Brenham Municipal Airport Terminal Building HVAC Replacment

RFP NO. 23-011– Addendum No. 1 Revised MEP plans

Revised MEP Plans:

New MEP plan set to replace current Attachment A and Attachment B. New MEP plans “Attachment A” for the Airport with the hood plenum incorporated and the captiveaire sheet added to the set.

MECHANICAL DEMO PLAN

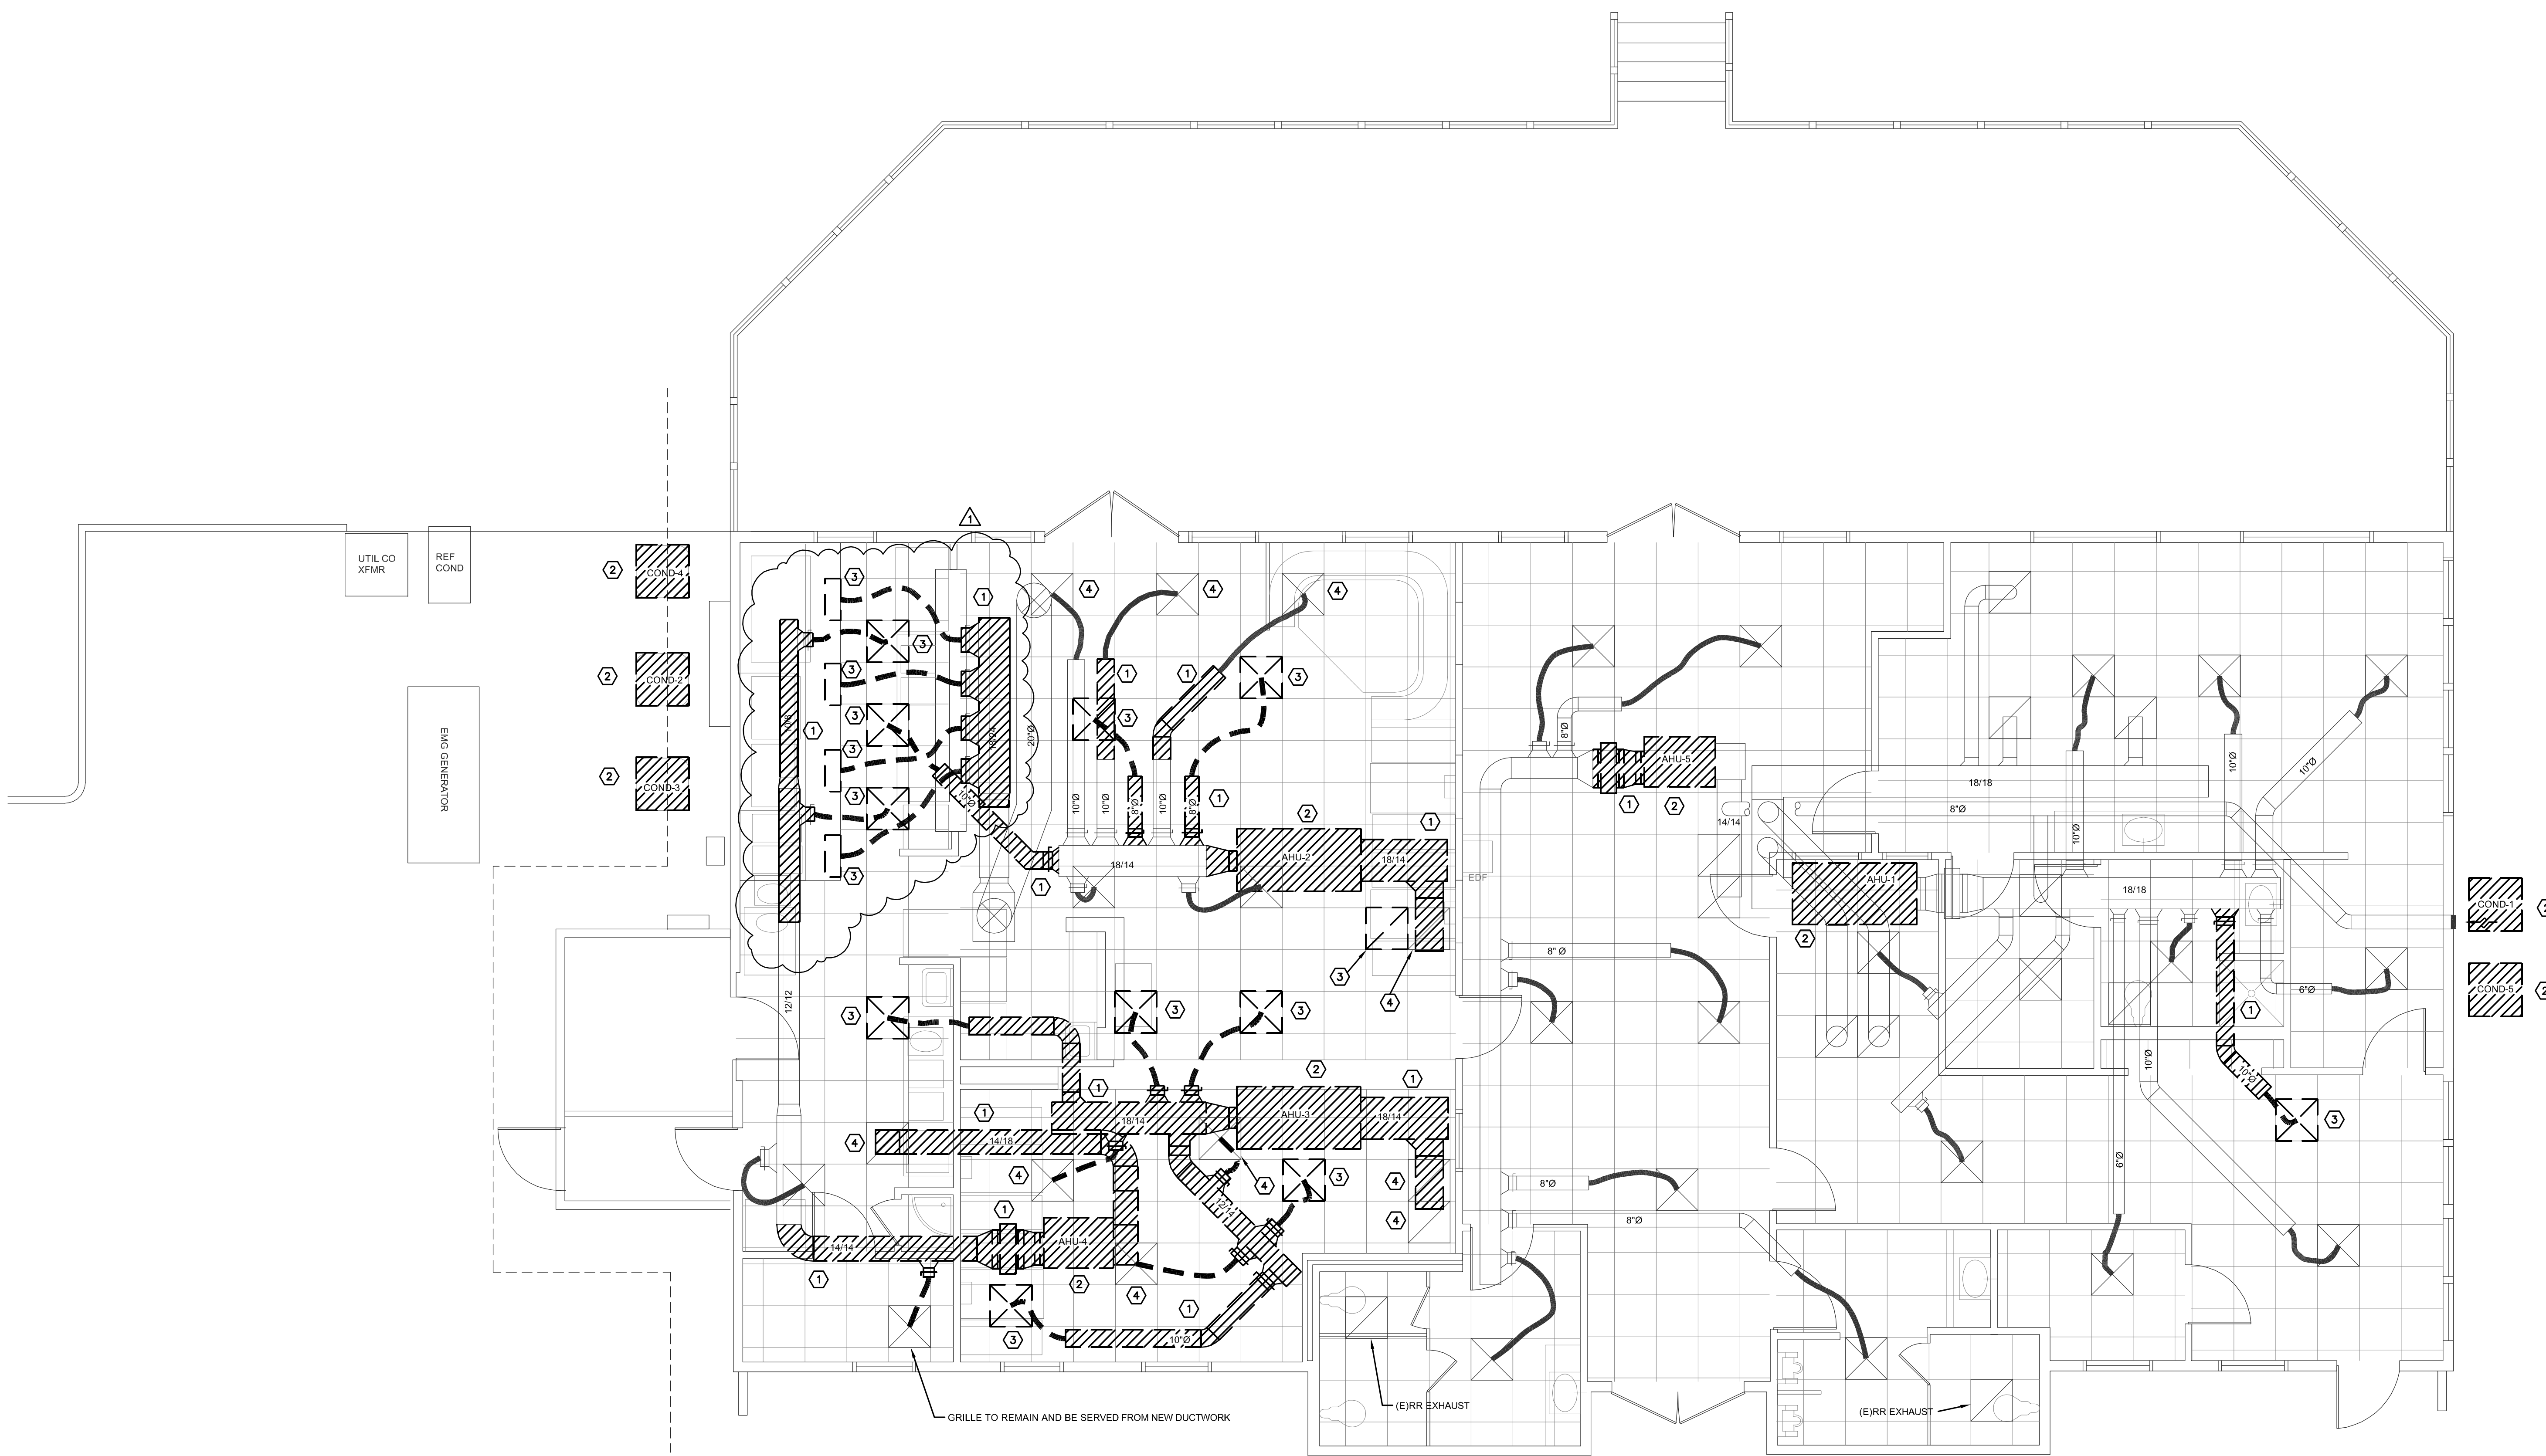
REVISIONS		
#	Date	Revision Notes
1	08/11/23	OWNER CHANGES ADD HOOD PLENUM
